04 August 2010

on behalf of GVEPA

## re: Armidale Regional Landfill – Environmental Assessment Project Application Number 06\_0220

*The Gara Valley Environment Preservation Association (GVEPA) seeks intervention by the NSW and Australian Governments to prevent the construction of a new putrescible landfill anywhere within the catchment area of the Oxley Wild Rivers National Park, which is part of the Gondwana Rainforests of Australia World Heritage Area (GRAWHA).*

Figure 22 – Maximum odour levels (ou) due to landfill operations – Staging 40-50 Years

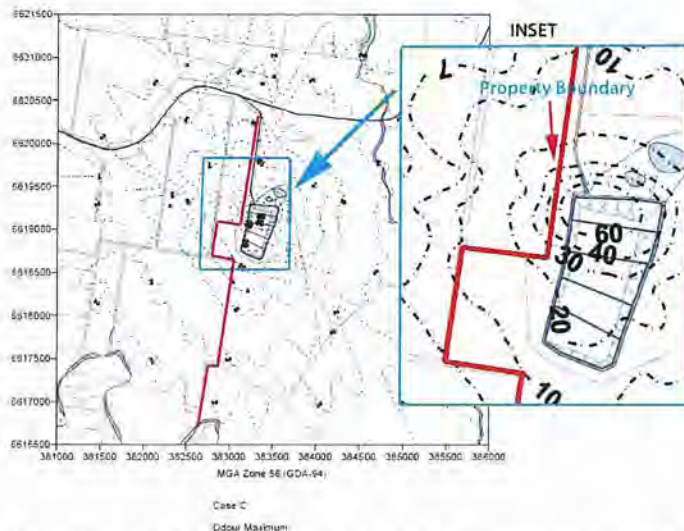
Figure 22 has been modified below to magnify an inset of the 'off site' odour levels projected by the proponent. As can be clearly seen, neighbouring properties will be subjected to odour levels of 30-40 OU and 3 houses and the Waterfall Way Gara Reserve picnic area subjected to Odour Units (OU) of greater than 3.

If the nuisance level of odour can be as low as 2 OU, GVEPA contend that 30-40 OU level predicted into the neighbouring property will be a 'stench'.

S041a_15	AQ1	<p>The Air Quality Assessment is presented in <b>Appendix O</b> of the EA and summarised in <b>Section 8.5</b> of the EA. Modelled predictions of odour levels were compared against relevant air quality criteria set by DECCW. Odour levels at the 99<sup>th</sup> percentile were shown to be well within the 7 odour goal at the nearest receiver and at the site boundary – refer to <b>Figure 23</b> of Appendix O. That is, odour goals were predicted to be met 99% of the time, in accordance with DECCW's odour goals.</p> <p>Council is unable to comment on the design and management practices at the Coffs Harbour landfill. Odour emissions from landfill are affected by several variables including meteorological conditions, surrounding environment, type and quantity of waste received and the type and efficiency of management practices. The Armidale Regional Landfill Facility would be commissioned and operated in accordance with current DECCW guidelines and the EPL.</p> <p>Total dust emissions due to the operations at the proposed landfill facility have been estimated by analysing excavation and landfilling for three stages of the proposed landfill. Predictions of dust generation were very low and it was concluded that the proposed activities would be unlikely to cause exceedances of the DECCW air quality criteria. Overall, predicted dust concentrations and deposition levels at all residential receivers were very low and it was concluded that there would be no significant impacts arising from dust emissions from the proposed landfill facility.</p>

Armidale Regional Landfill - Noise Impact Assessment

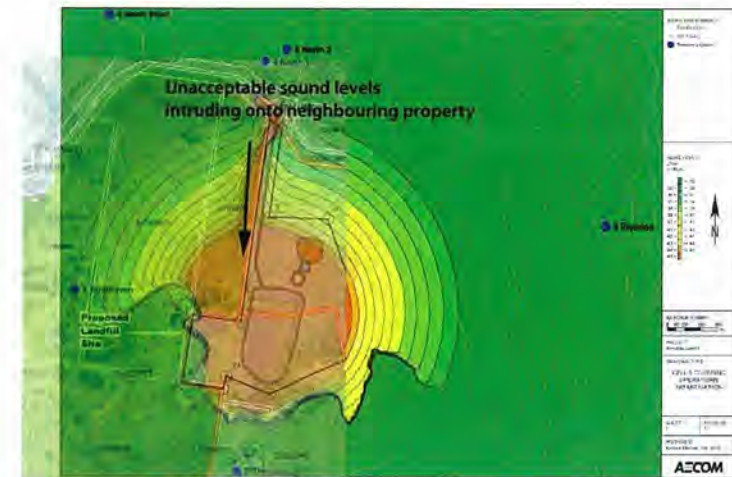
Site layout has been superimposed on chart to show property boundaries and insufficient 50m buffer.

Noise from operation and construction of new road hugging neighbouring boundary has not been assessed. There is no data on the access road type. If 'cutting' into the hillside will be employed for construction of the road there must be reflected sound impacts on neighbours that have not been assessed. The noise from the entrance road as shown in the above diagram does not indicate this. Concerns are also raised from residences North of the proposed site entrance that traffic direction into and out of the site will raise noise levels significantly due to acceleration and deceleration of heavy vehicles. As these vehicles will be accessing the site perpendicular to current traffic flow with exhaust noise directed at the residences impacts will be significant.

Regional Landfill Siting Study, Final Synthesis Report  
Page 60

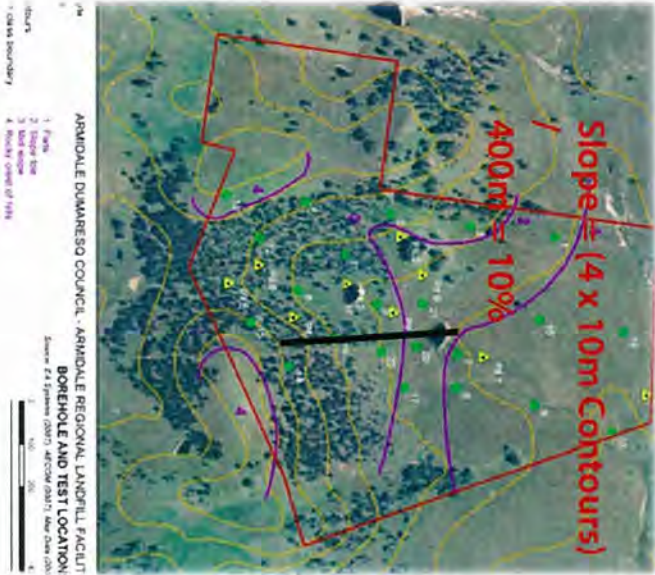
Criterion 7 - Site Features	Topography/Terrain
Capacity	Sloping site from maximum 600 metre elevation to 600 metres
Capacity	Slopes of up to 15% are acceptable
Capacity	Capacity between 50 and 100 years would be more suitable subject to detailed design and analysis

Simple graphic analysis of contours shows a general slope of over 10 %.
